FIELD CHANGE ORDER

NUMBER: DS-650Q1-F001

MIRA MicroVAX 3000, DS-650Q1-A2/A3 (also called MIRA 3200) shipped before 03-JULY-1989 require this FCO. System revisions are not significant for the application of this FCO. They are built with M7763 or M7764 at Rev D or below.

INTERCONNECTION OF MIRA MODULES (SYSTEM A only is shown)

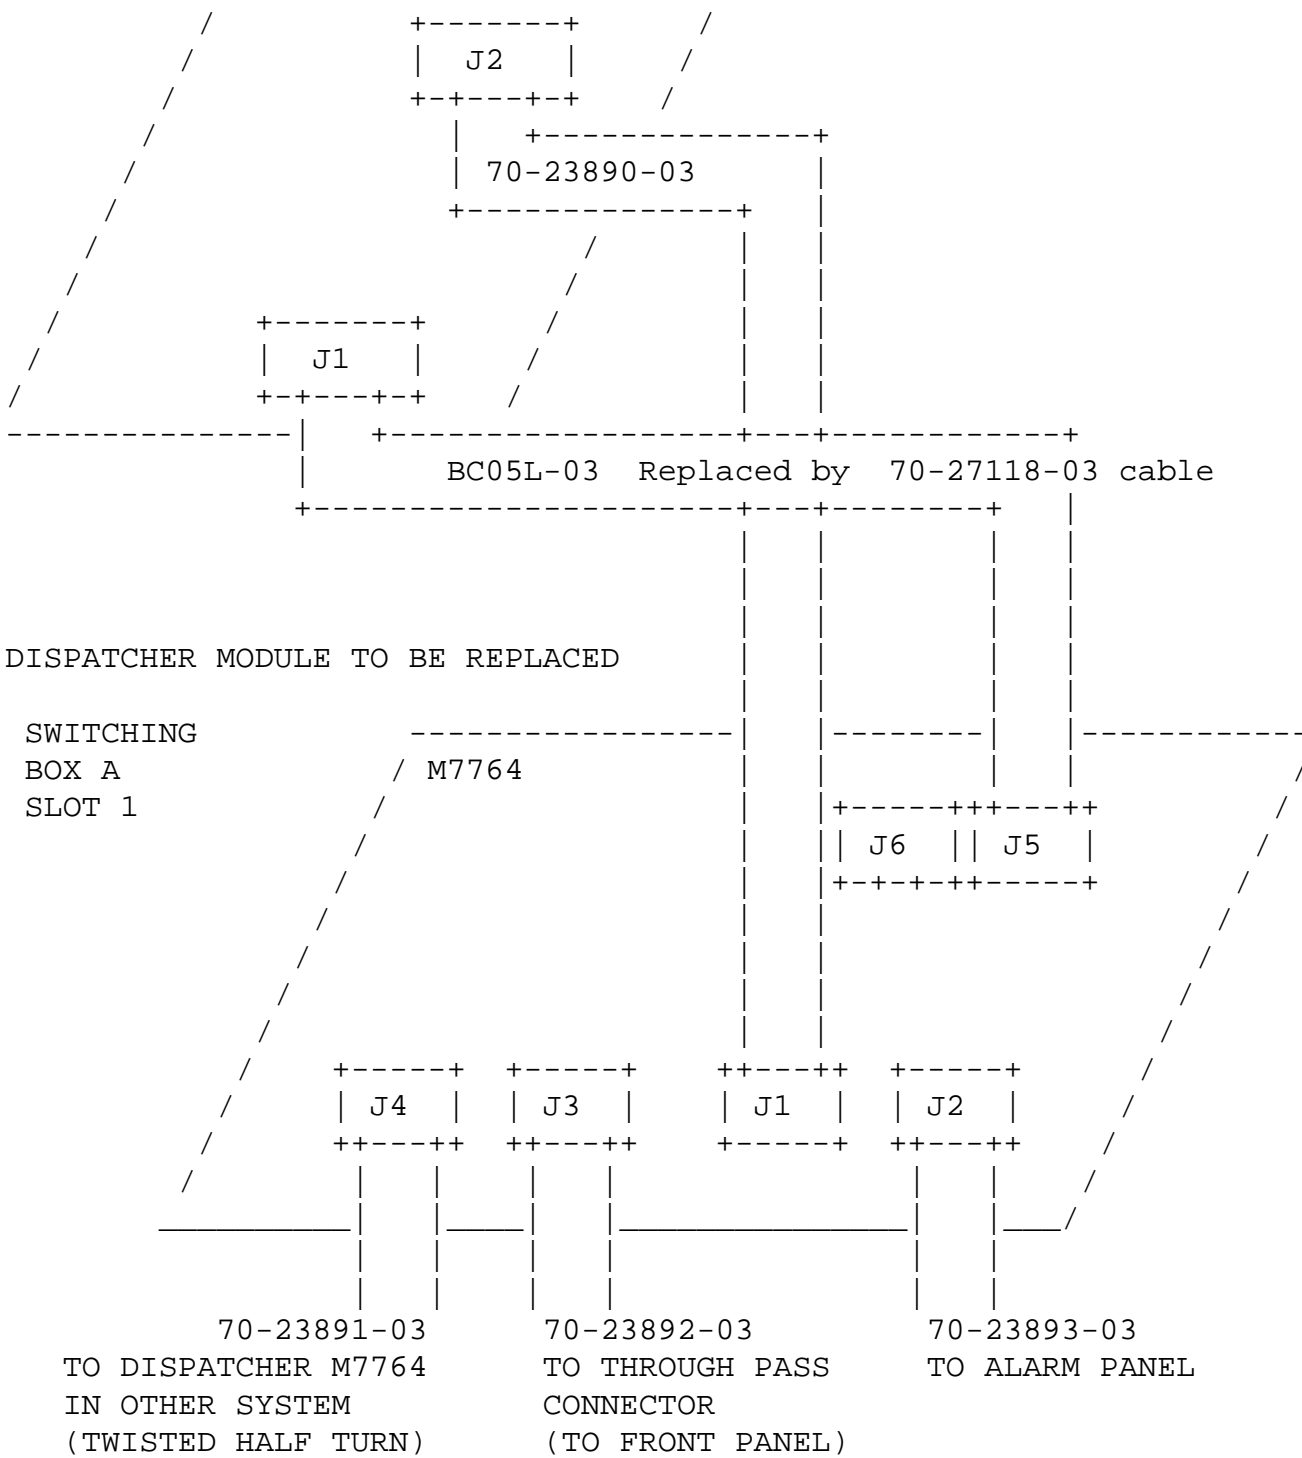
Intermittent data corruptions happen when testing switched KMV1A with MDM Diagnostics in MIRA Systems. The data was corrupted by cross-talk between cables generated by the BC05L cable between the MIRA watch-dog Module (M7763-00) and the dispatcher module (M7764-00).

A re-layout of the two modules M7763-00 and M7764-00 has been necessary to adapt the impedances between these modules. Both M7764 and M7763 become Revision E with the new etch. A new cable 70-27118 has been designed to replace the BC05L cable.

WATCH DOG MODULE TO BE REPLACED

Replace all modules M7763 and M7764 at Revision D or below by new modules at Rev. E and replace BC05L dispatcher cables at one time.
